# Hi-Fi Products Service Bulletin

**Model:** CDP-C265

**No.** 455

**Subject:** Disc Table will not stop Rotating

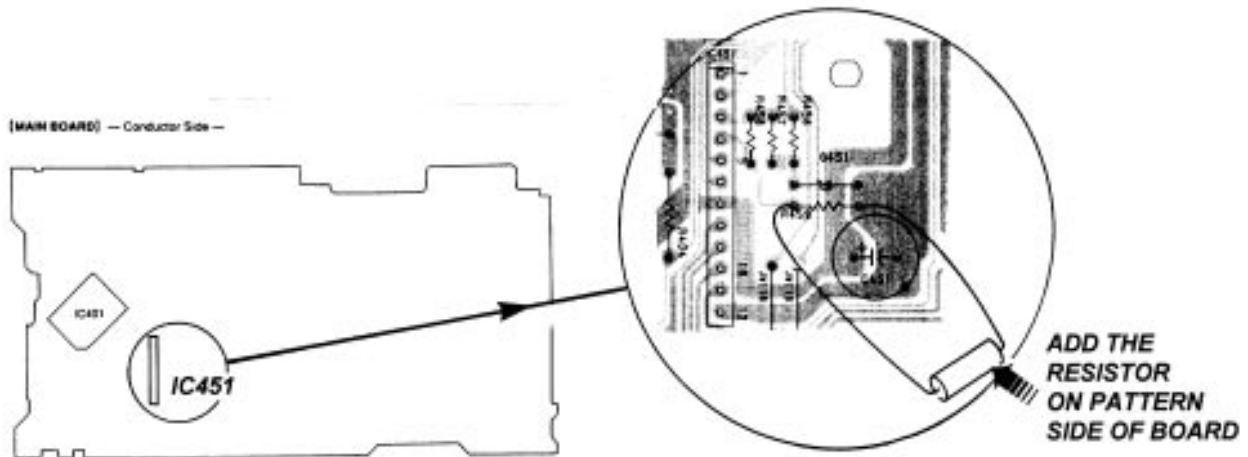
**(62)** The disc table (B) rotation speed is too fast and will not stop rotating.

If this problem is seen, note the serial number of the unit and add the proper resistor in parallel to R459 (1.2K ohm). The additional resistor (listed below) should be added to the foil pattern side of the PCB.

SERIAL NO. RANGE	8000101 - 8000682		8000001 - 8000100 8000683 - 8018074	
	DESCRIPTION	PART NUMBER	DESCRIPTION	PART NUMBER
	7.5K OHM	1-247-852-11	12K OHM	1-247-857-11
